IMPEDANCE

The proposed change in Return loss specification for 100 Mbit HSTR is large, and a change of this magnitude is not required for allowing simple dual impedance designs. In the following is the minimum change in return loss requirements estimated.

Figure 1 Return loss for a 150 Ohm design with 8pF stray capacitance

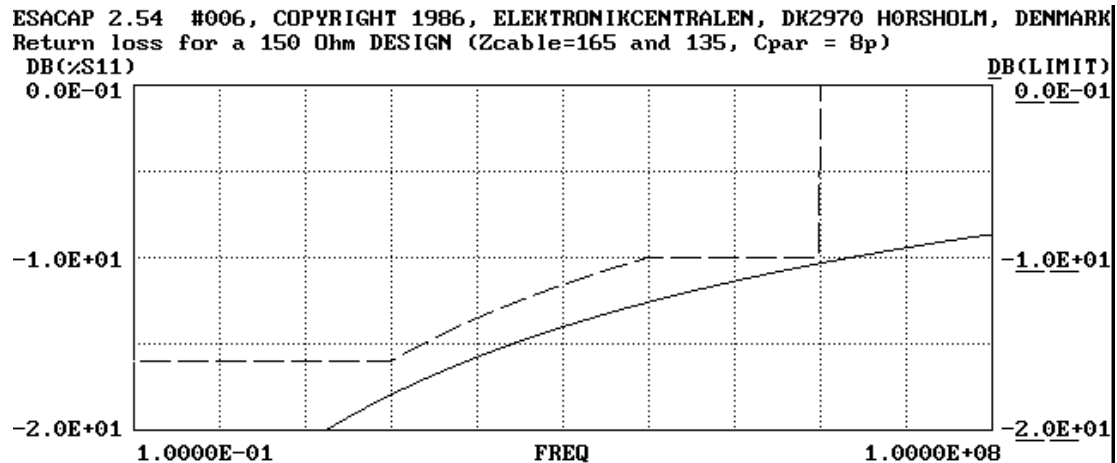
In almost all cases is the return loss at high frequencies limited by parasitic capacitance in the circuit. With this assumption is the maximum allowed capacitance for meeting the return loss requirements in a 150 Ohm design is 8 pF. (figure 1)

If a 150 Ohm design with less than 8pF stray capacitance's is possible, is a compromise impedance design with the same stray capacitance also possible !. If the HSTR standard shall allow up to 8 pF stray capacitance (Read: A compliant compromise design is not more difficult than a compliant 150 Ohm only design !!!!!): The return loss limits are then:

Greater than 14 dB	from 2MHz to 37.8MHz
Greater than (14-20 log(f/37.8MHz))	from 37.8MHz to 60MHz
Greater than 10 dB	from 60MHz to 80MHz

Figure 2

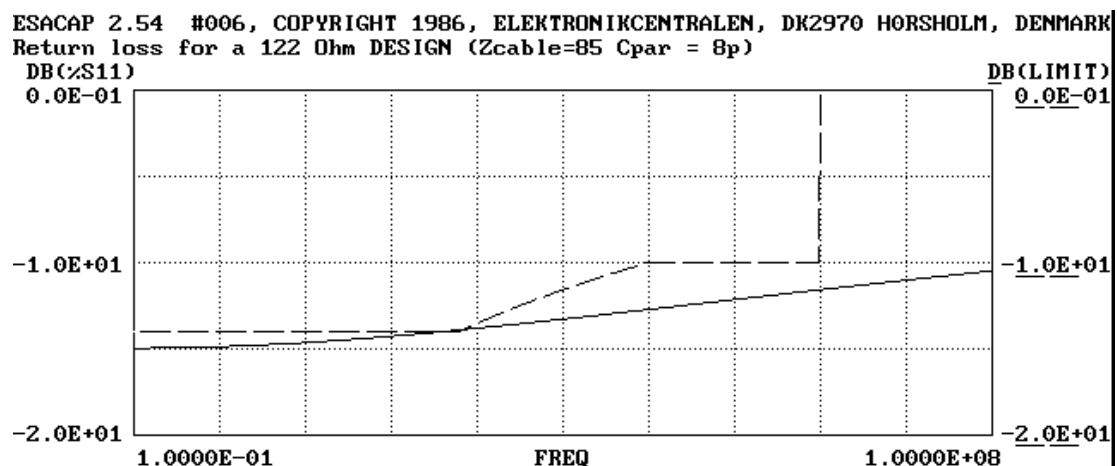
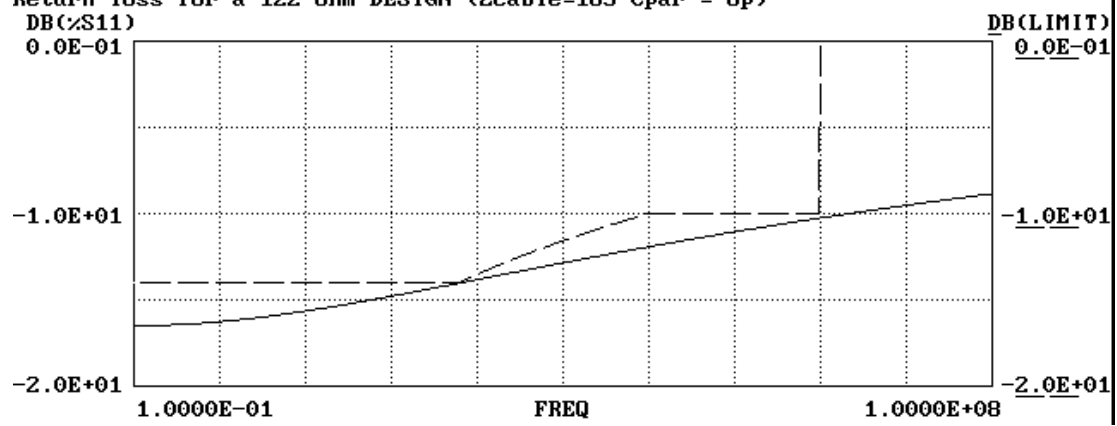
The return loss for a 122 Ohm design at the impedance extremes (85 Ohm and 165 Ohm) with 8pF stray capacitance are given in figure 2 and 3.

ESACAP 2.54 #006, COPYRIGHT 1986, ELEKTRONIKCENTRALEN, DK2970 HØRSHOLM, DENMARK
Return loss for a 122 Ohm DESIGN (Zcable=100, Cpar = 8p)

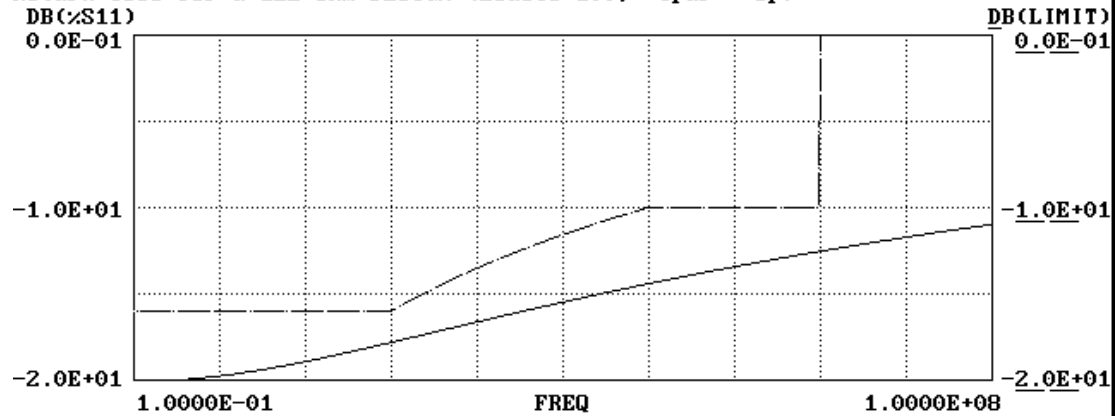
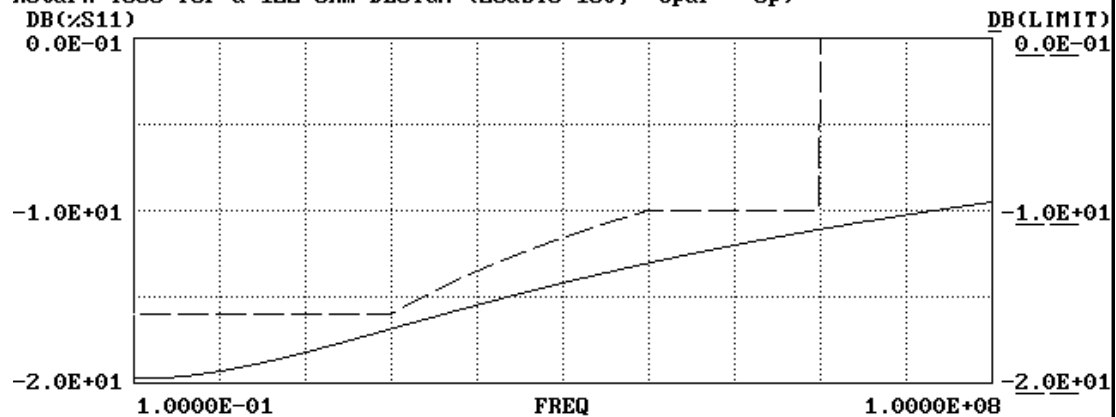
In the two following figures is the return loss for 118.5 Ohm design shown. The reference impedance used for the simulation is the nominal impedance (100 and 150 Ohm)

The figures shows that the dual impedance design is OK if the return loss is only measured at the nominal impedance.
